**ADDENDUM NO. 3**

DATE: February 10, 2020  
PROJECT: ITB 20253  
BETHUNE POINT WRF-PHASE I PROCESS UPGRADES  
OPENING DATE: ~~February 17, 2020~~ February 27, 2020

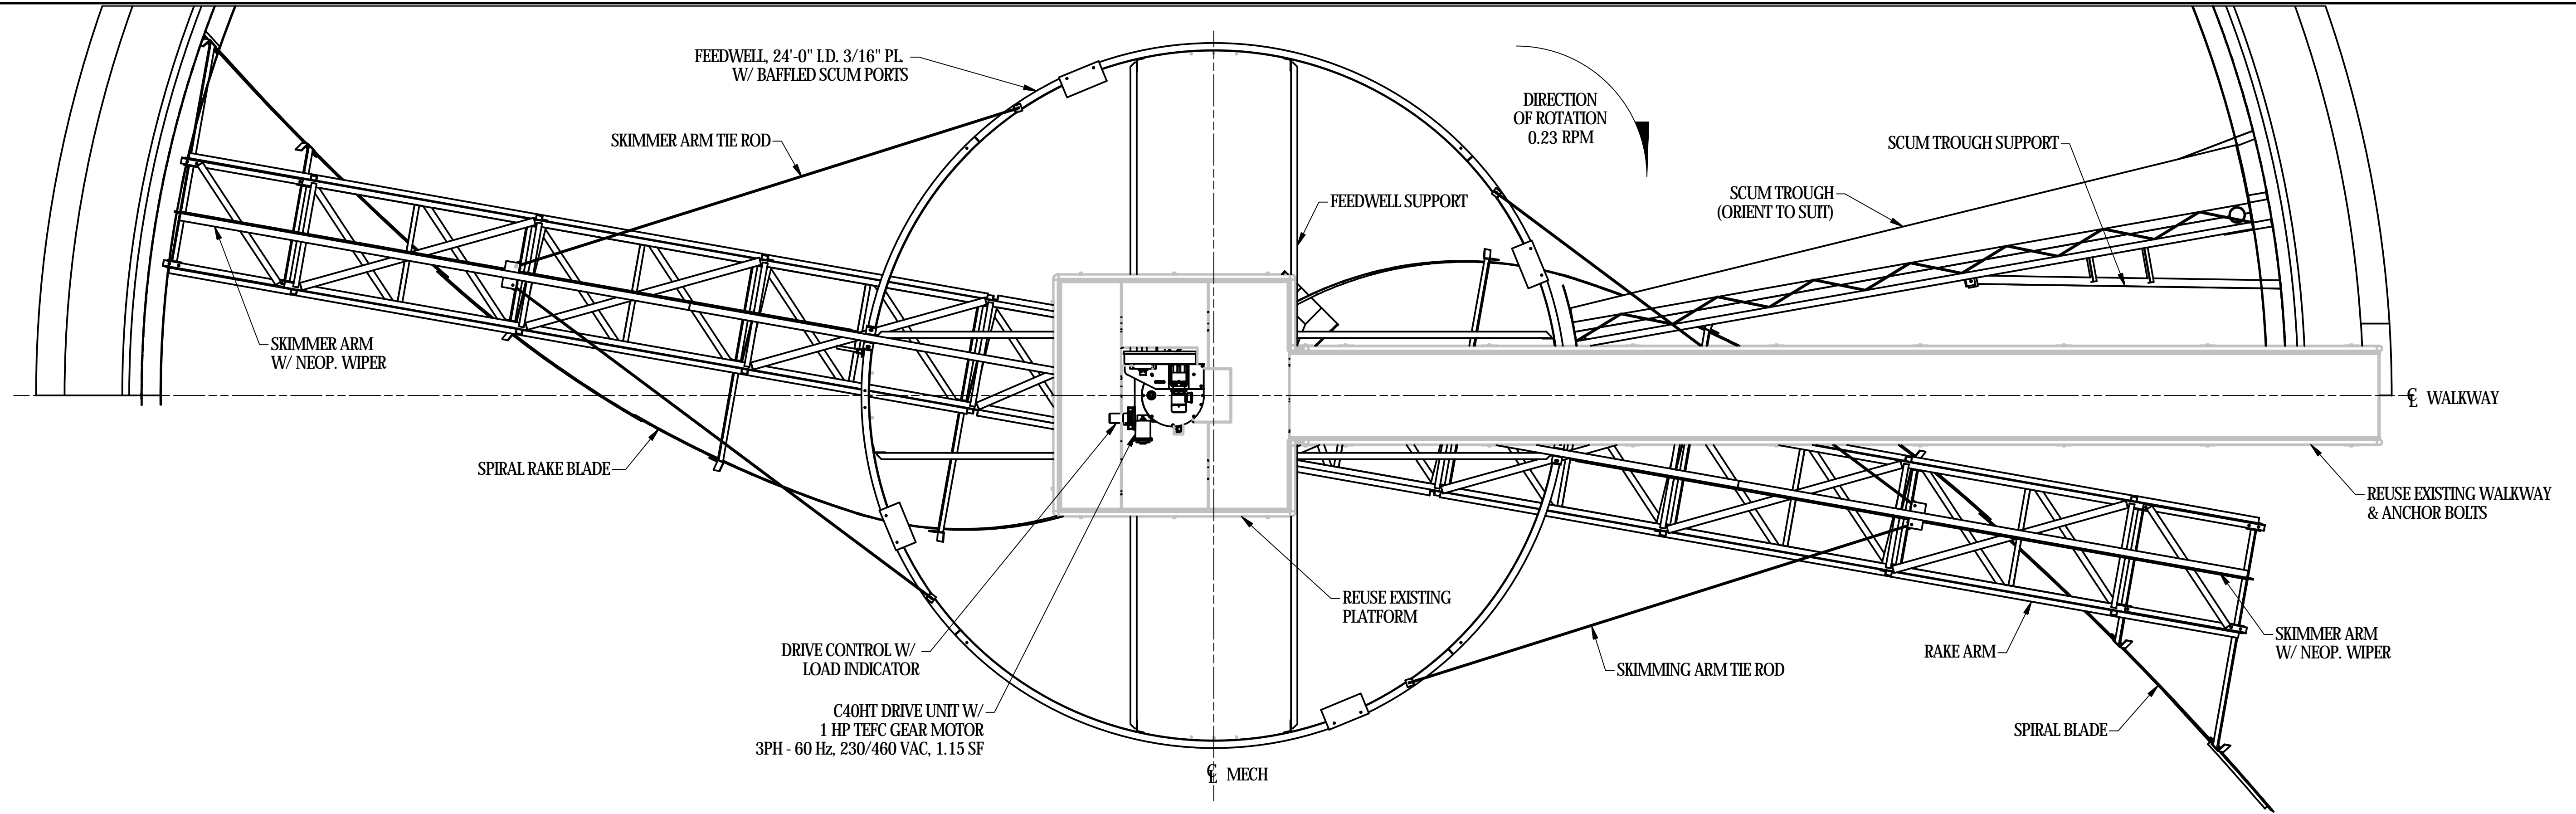
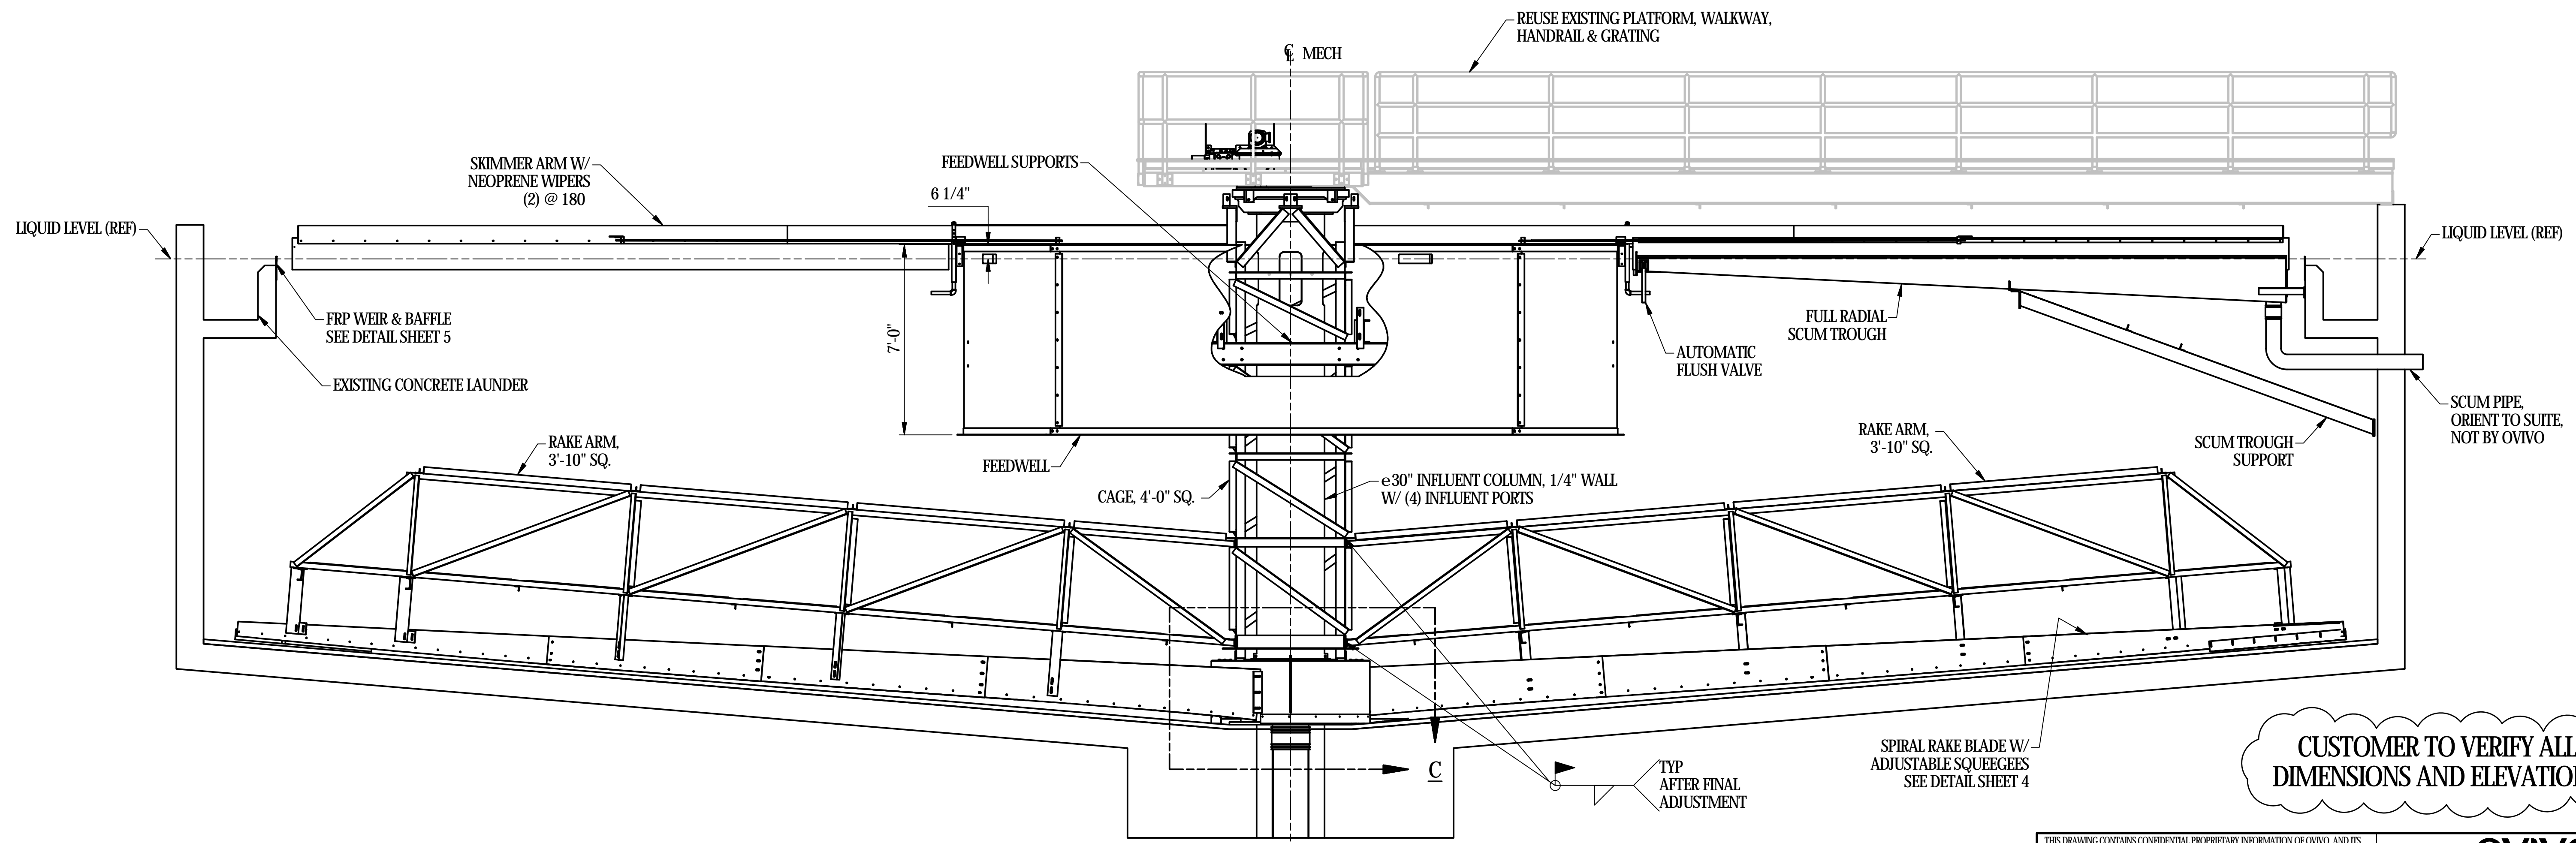
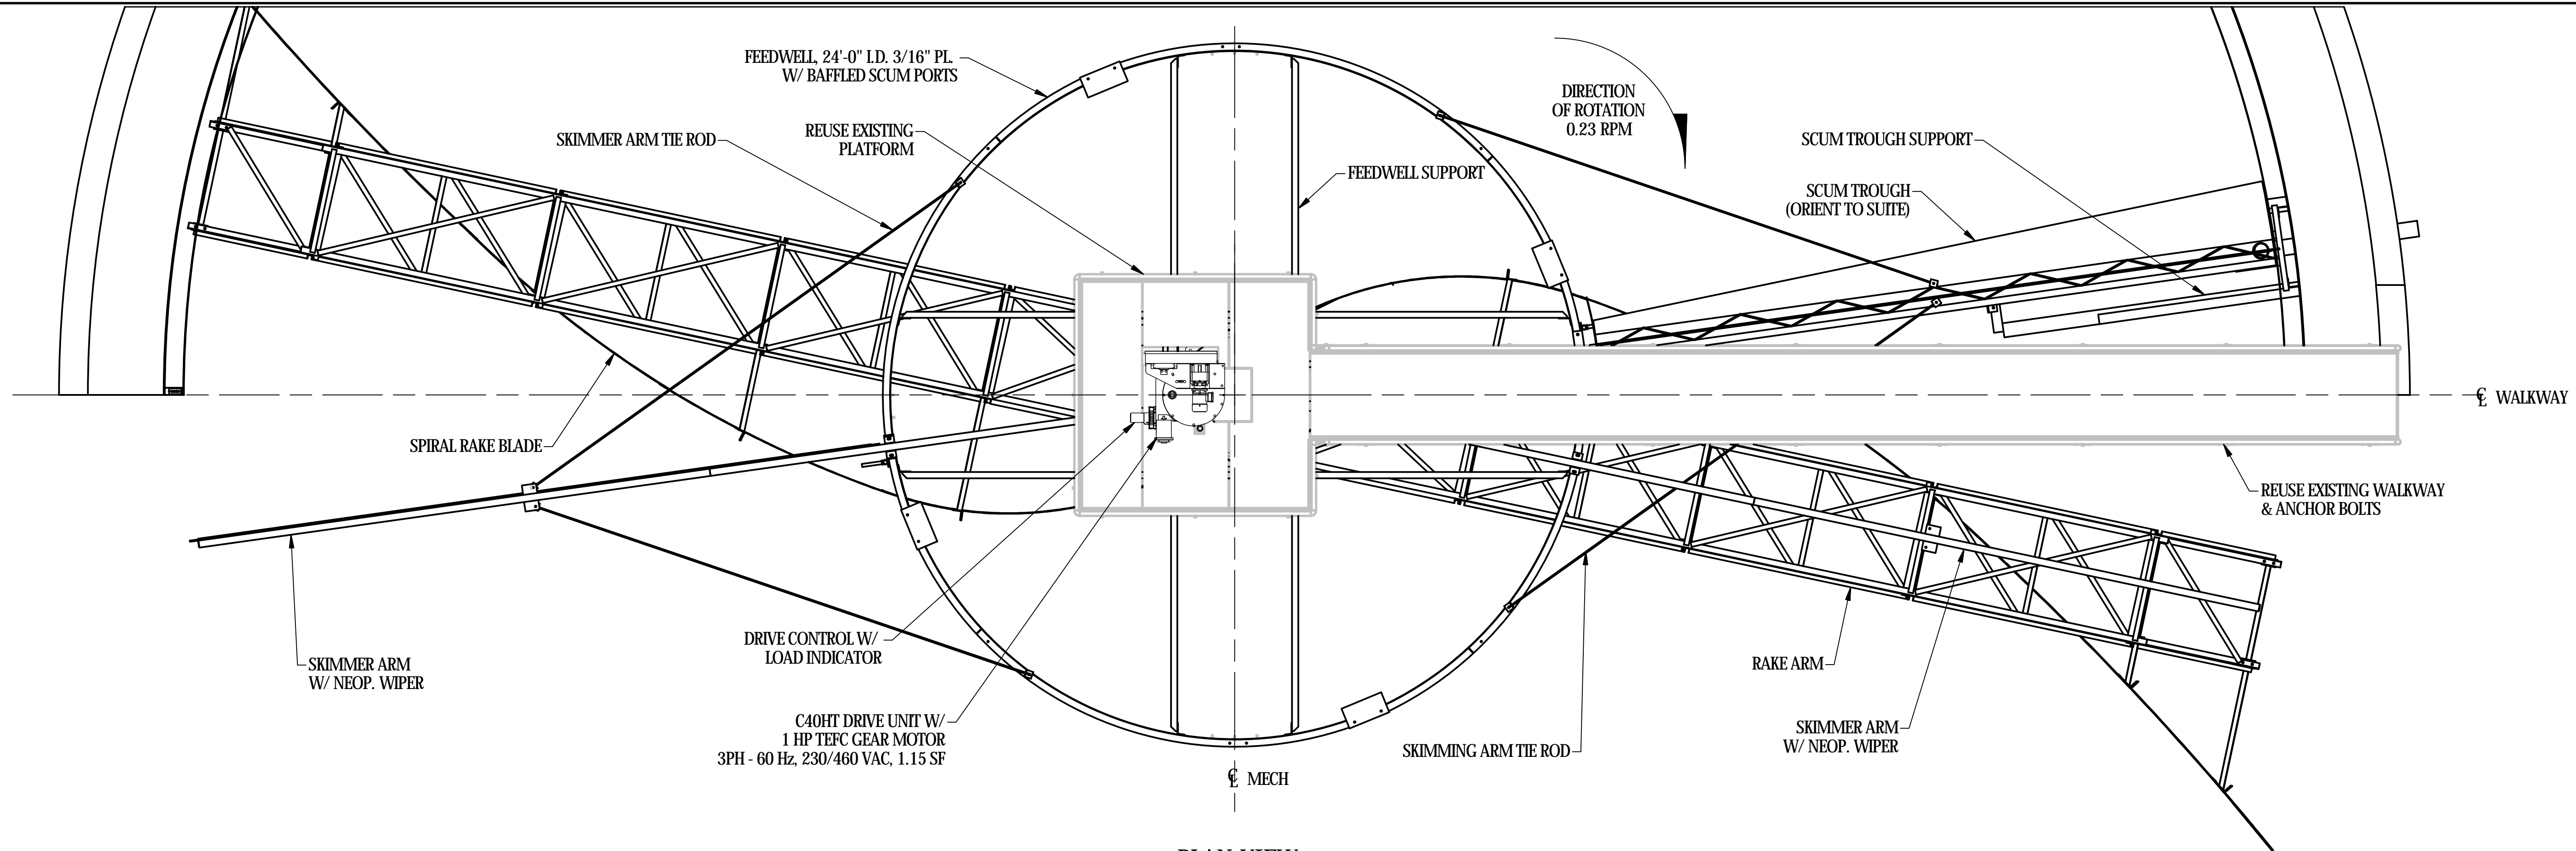
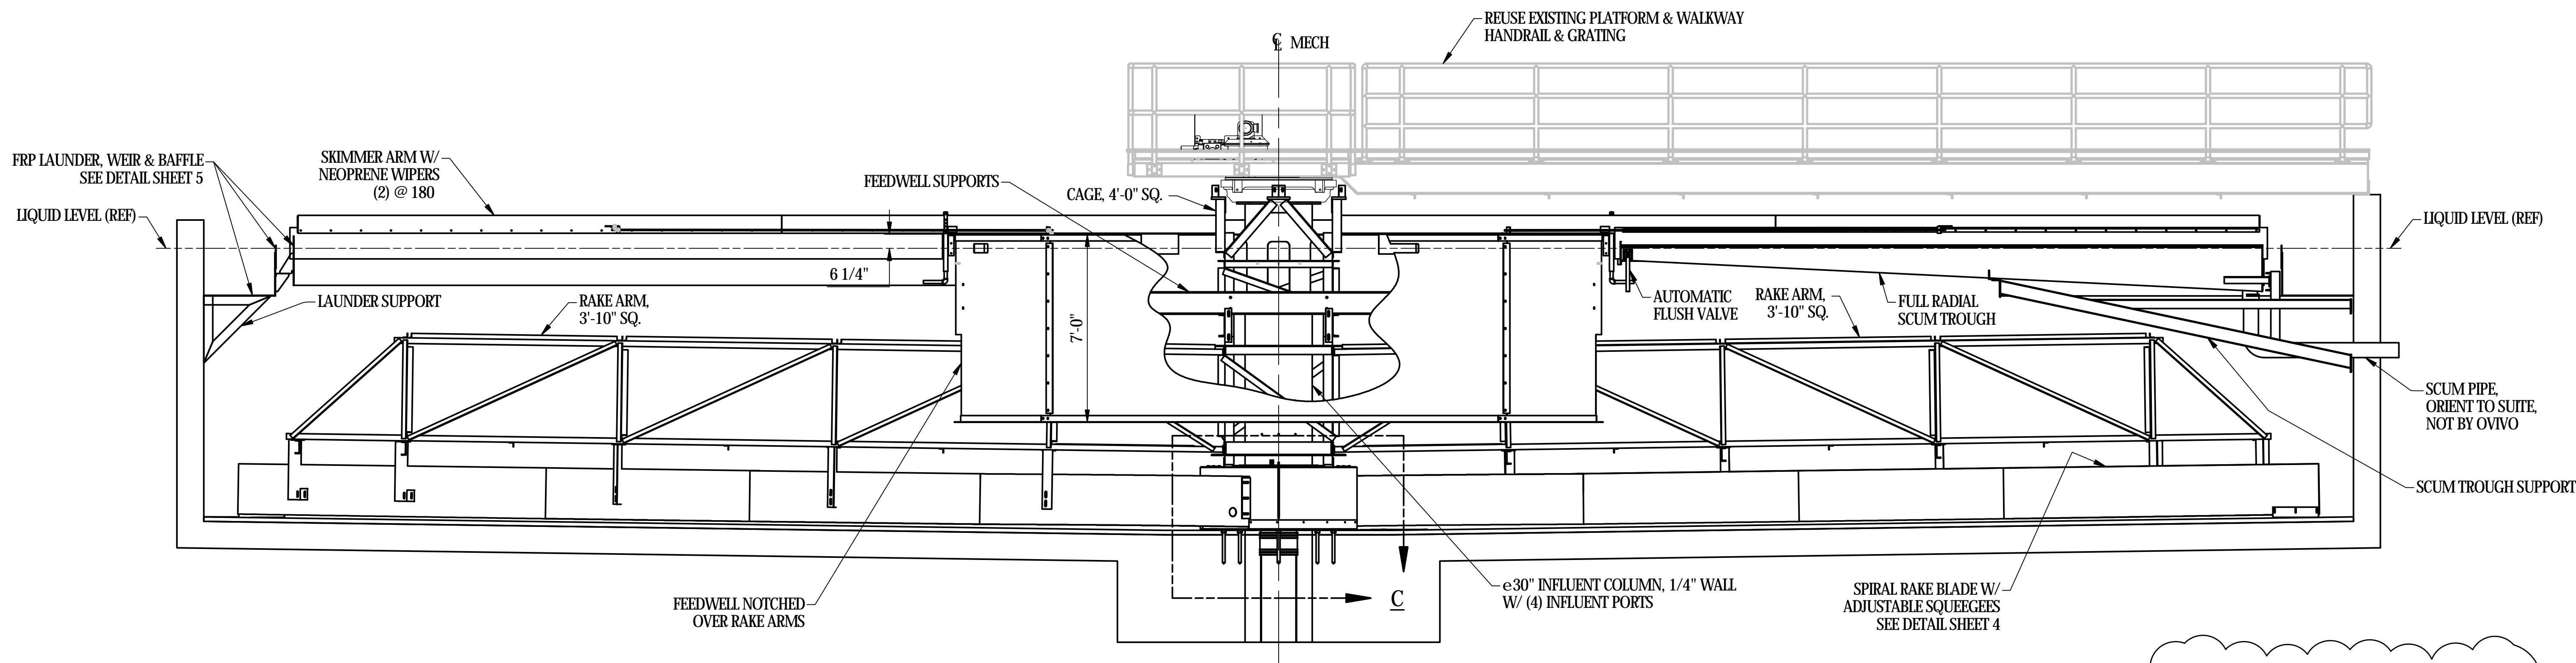
- Critical dimensions with regards to depth of the mechanism are currently unable to be verified due to the tanks being full and buoyancy concerns within Clarifiers No. 1, 2 and 4. A provision is being added into the bid documents (via Addendum No. 3 which is forthcoming) to direct the successful Contractor to obtain these measurement within 4 weeks of being issued Notice to Proceed. To that end, the City requests that Ovivo begin production of all components except those for which these measurements are necessary. From previous conversations it is our understanding that those components are limited to the center support column and the cage.
- The City requests that Ovivo please commit to fabricating the center column and cage (and any other items tied to the needed measurements) as soon as is feasibly possible upon receiving the measurements so as to keep the project on schedule.
